RE: Johnson/PLN210061

Re: Johnson Hal W Jr. & Allison H; File No. PLN210061; May 28, 2025 Monterey County Planning Commission, Agenda Item No. 2.

Re: Response to Peer Review Comments for  
Proposed Development at 226 Highway 1  
Carmel Highlands, California  
Monterey County APN 241-182-003

SUBJECT:           **RESPONSE TO PEER REVIEW COMMENTS**  
Proposed Single Family Residence  
226 Highway 1, Carmel, California (Previously 244 #3 Highway 1)  
APN: 241-182-003-000

PLANTING PLAN

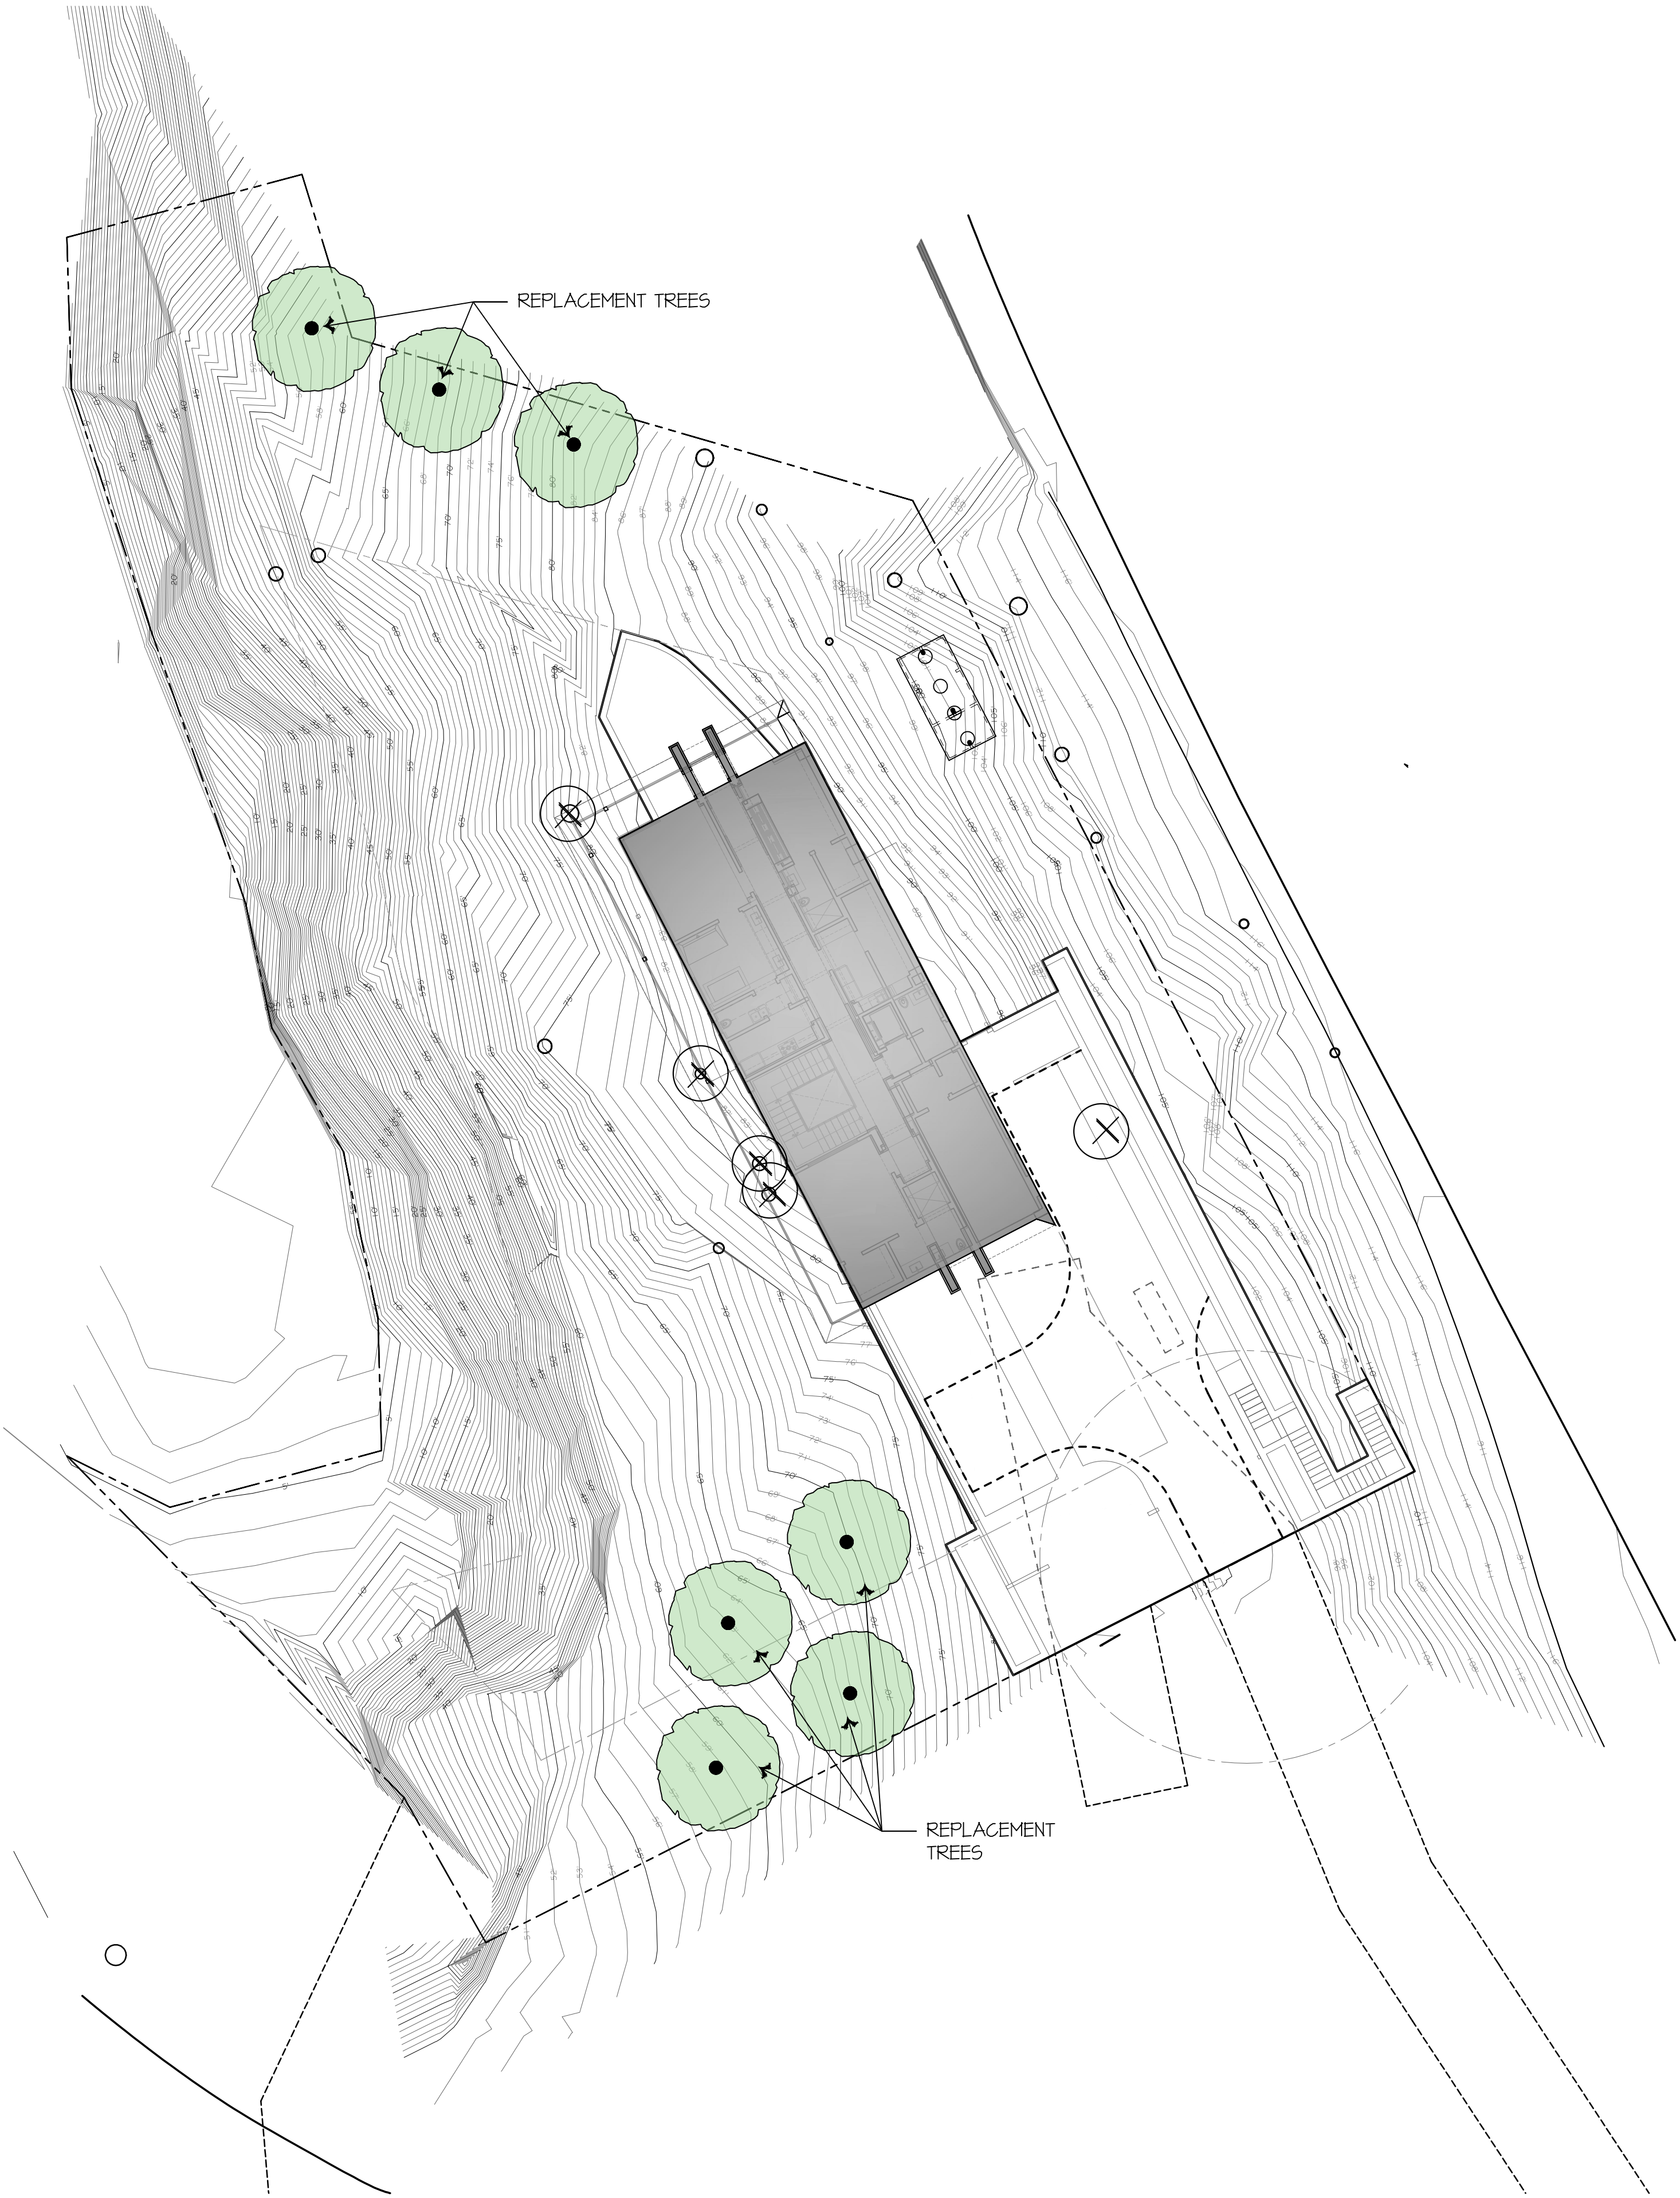
In terms of replacement trees, we had asked the Project applicant to provide a copy of the Landscape Plan shown on Sheet A1.1. The Project plans currently require four replacement trees. Sheet A1.1 showed three replacement trees on the northern elevation of the Project residence. On May 27, 2025 the applicant's attorney provided a copy of the Landscape Plan dated May 23, 2025 that included the three trees along the north plus four new trees on the south that would block coastal views from Owner's residence. (See Exhibit B.) The existing trees proposed for removal do not block such views. We raised these concerns with the applicant's attorney who indicated that the architect may have misunderstood the request and indicated a willingness to work with the Owner on the location of the replacement trees. Along those lines, if the Project were to be approved, we ask that a condition be imposed to require Owner's consent to the location of the replacement trees.

Feature A – A deposit of Qoal.

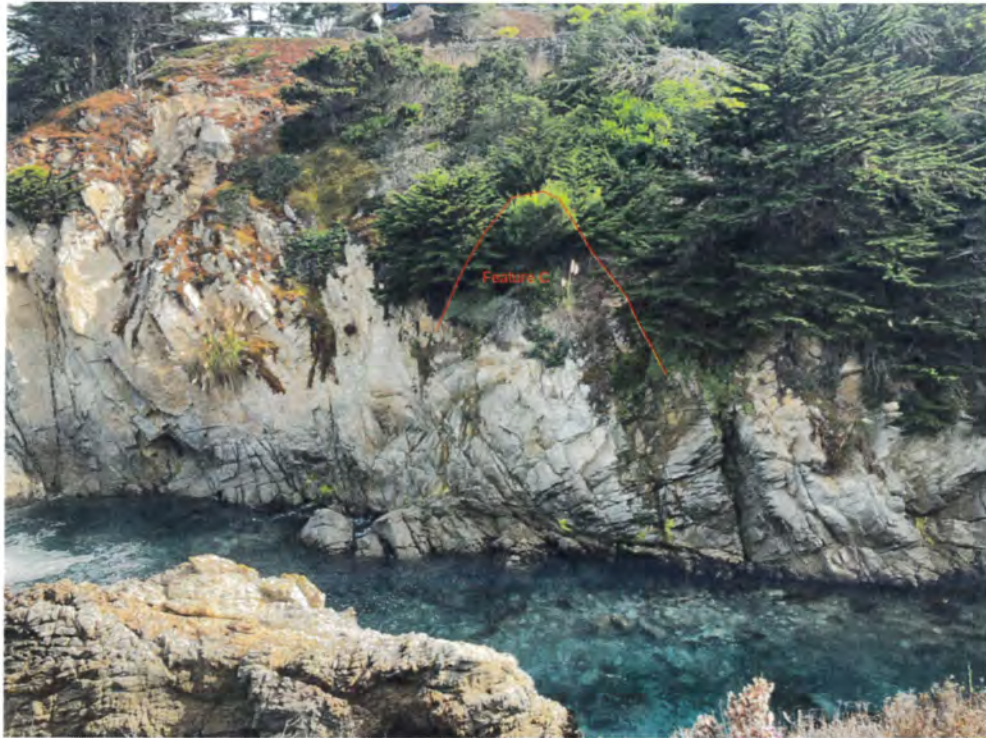
Easton Geology Response: Feature "B", as delineated by the reviewer, is located below the joint-bounded scarp mapped by our firm. Formation of the joint-bounded scarp appears to be the

Easton Geology Response: We do not believe that Feature "C", as delineated by the reviewer, corresponds with any mapped slope instability features mapped by our firm. The location of "Feature C" on the photo markup by the reviewer lies in the northernmost portion of the parcel, is coincident with a shallow drainage swale, and appears to be 60 or more feet from any proposed improvements. The joint-bounded headscarp referenced on our geologic map was discussed above and corresponds with Feature "B" delineated by the reviewer.

result of a wedge failure within the weathered granite on the upper bluff. We measured two adversely dipping joint sets in this area, and their resulting line of intersection (the axis of sliding) trends 228AZ and plunges approximately 47 degrees to the southwest. The upslope trend of the axis of sliding passes well north of the proposed residence. Current revised plans for the project depict the proposed residence about 30 feet from the left margin of the mapped wedge failure scarp depicted on Plate 1 of our report and is at least 40 feet from the axis of sliding. The footprint of the proposed residence and its foundation will not be affected by potential enlargement of this slide feature. We saw no wedge failures of similar or larger size during our investigation.

**Figure 5 Project Elevation Profile**

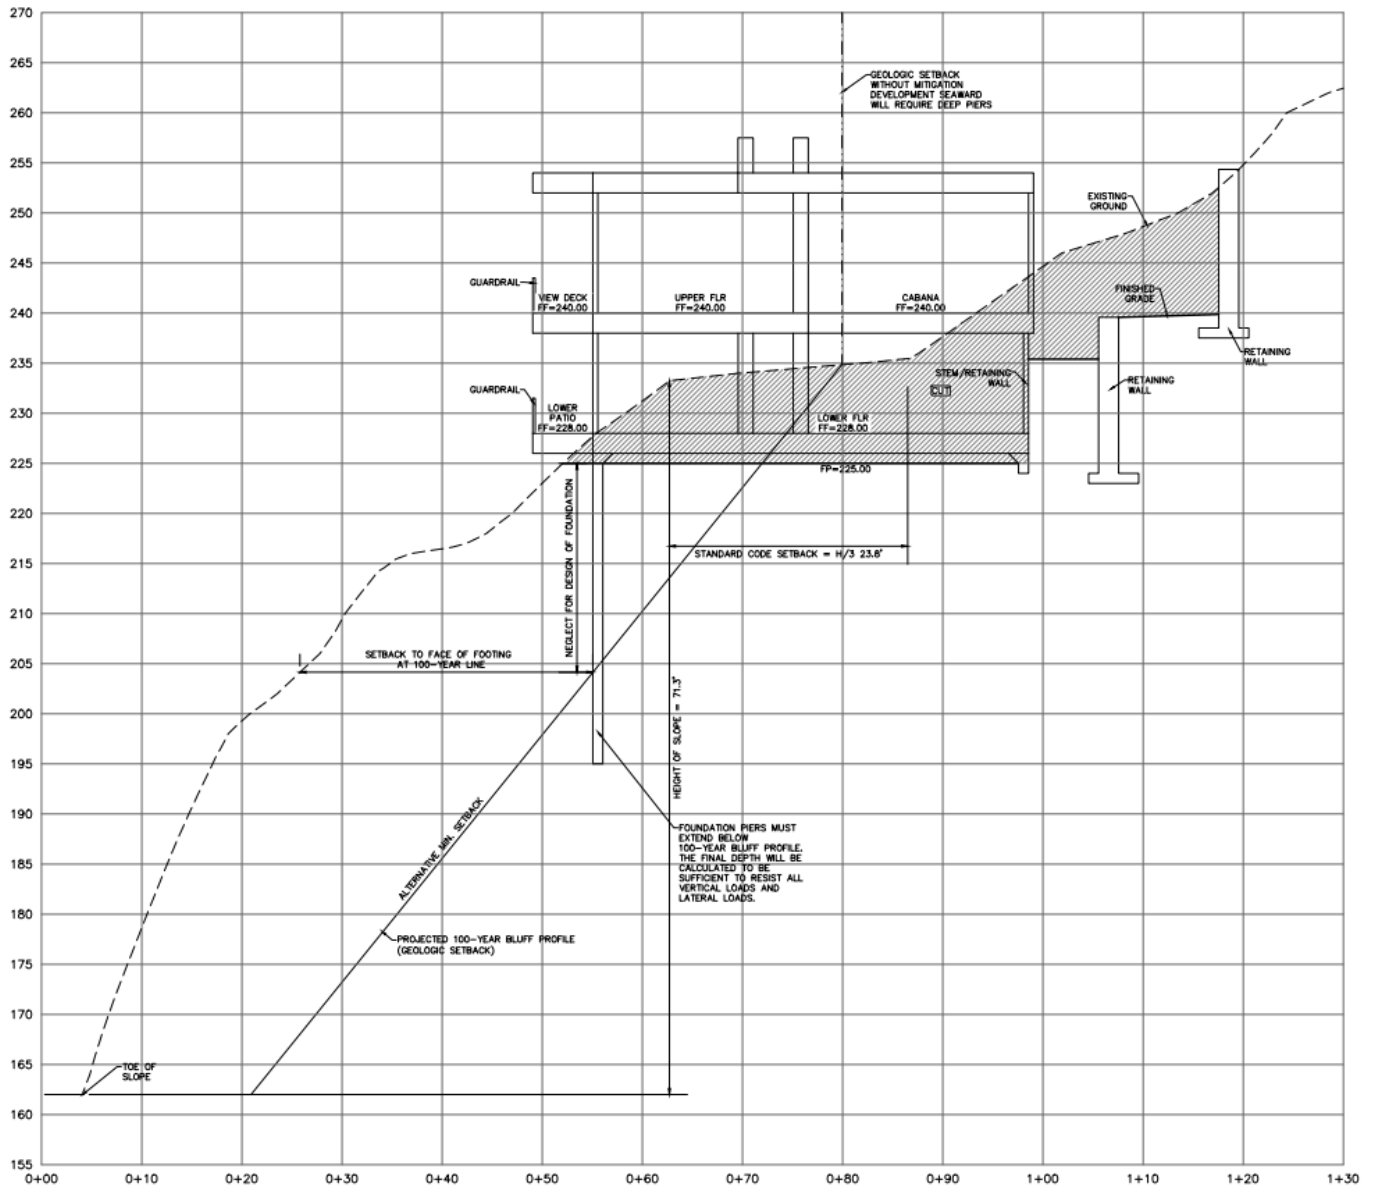
<sup>1</sup> Figure 5 (Project Elevation Profile) of the MND shows how the majority of the Project extends beyond the geologic setback line, protruding over the steep coastal cliff face. A copy of this figure is attached hereto as Exhibit A.

"GRADING & DRAINAGE PLAN - LOWER"

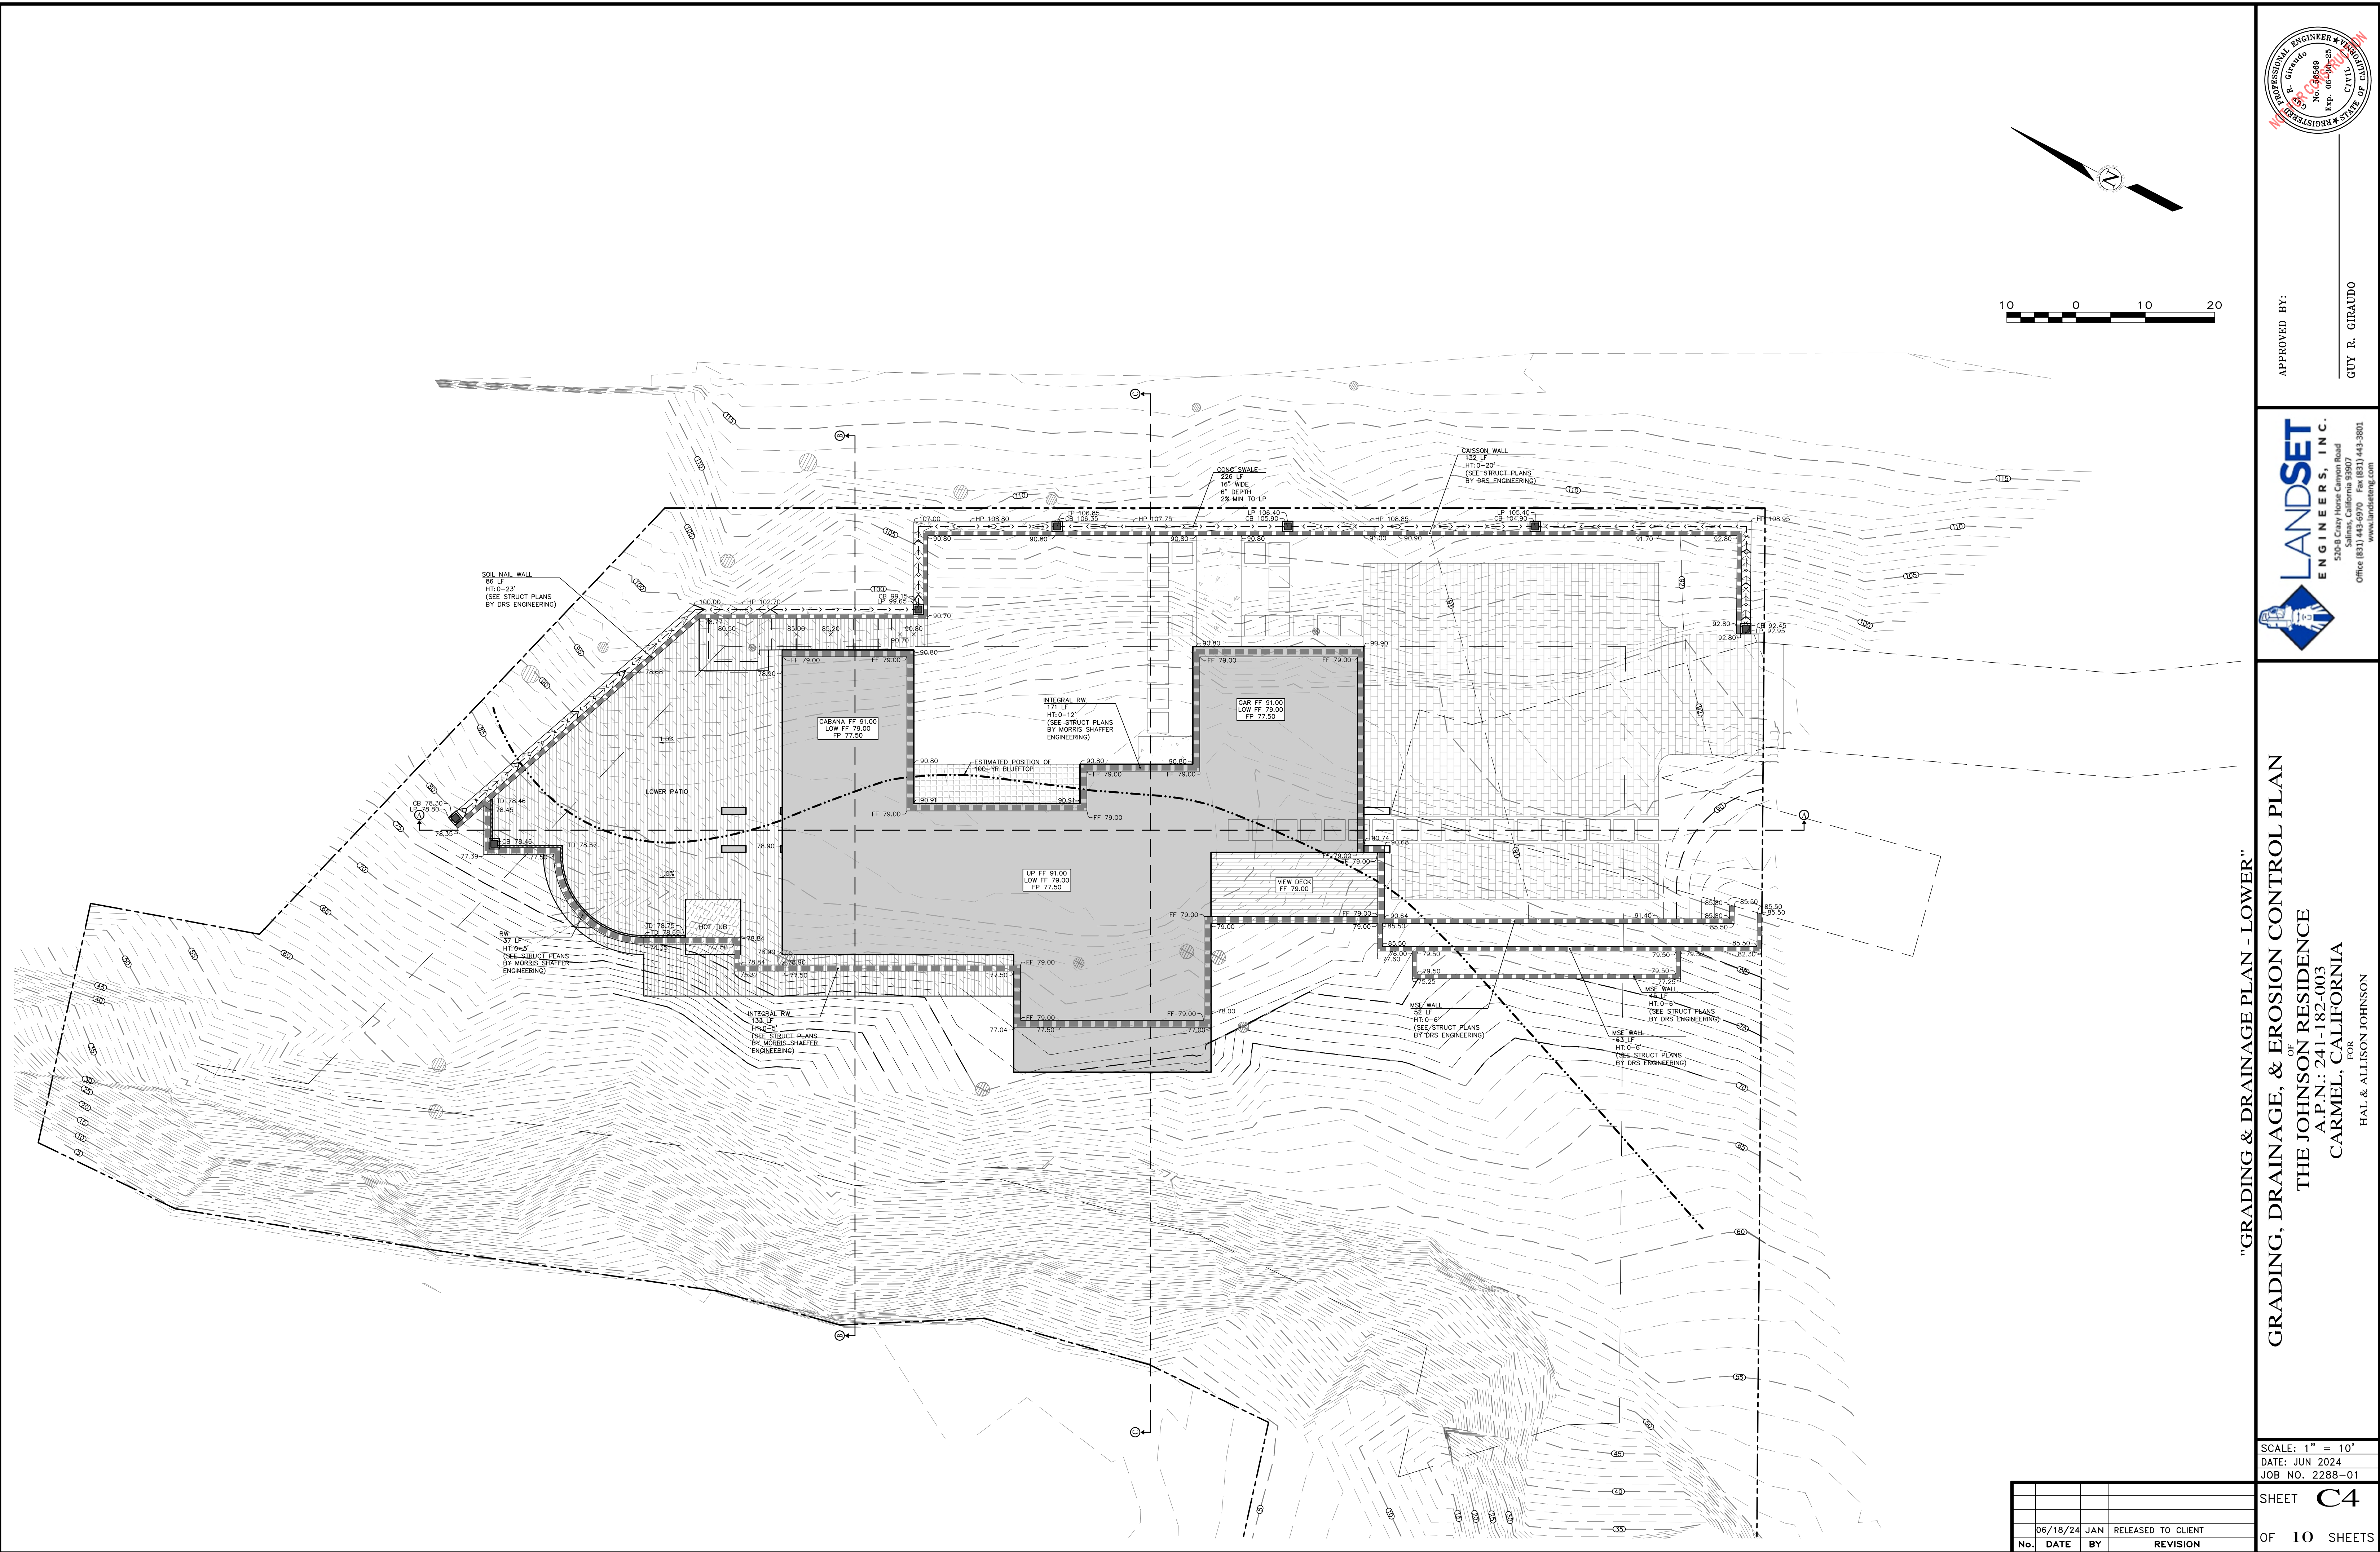
Comment 8 (p9): *Rock bolts are to be designed to retain significant cuts into the granitic slope near the property line. It is recognized in the geotechnical report that an easement will be required where rock bolts will extend into Caltrans right-of-way. In addition, walls along the east side of the property, or the east side of the easement to the property, where a failure could potentially affect Caltrans property or facilities, will likely have to be submitted to Caltrans for review prior to approval. Further any drainage culverts including the one previously mentioned entering the property from the upslope area will need to have adequate catchment and disposal away from the building areas.*

Response 8: The Architect has been coordinating with Caltrans on the previous design (June 2024) and review for the proposed walls. The retaining wall near the east property line had been designed with permanent caissons to avoid the use of rock bolts and therefore eliminate the need for an easement. A drainage plan was prepared by a Civil Engineer. The plan included a swale at the top of the site retaining walls to collect any runoff from upslope and direct it to an appropriate discharge point.

As the plans have been revised, significant cuts and retaining walls near the property line have been eliminated. The new site plan includes terraced retaining walls at the driveway that are a maximum of 6 feet tall and are setback 10 feet from the property line. These walls will likely be designed as simple gravity walls without the need for caissons or tiebacks.

The civil engineer will provide a revised drainage plan for the construction drawings.
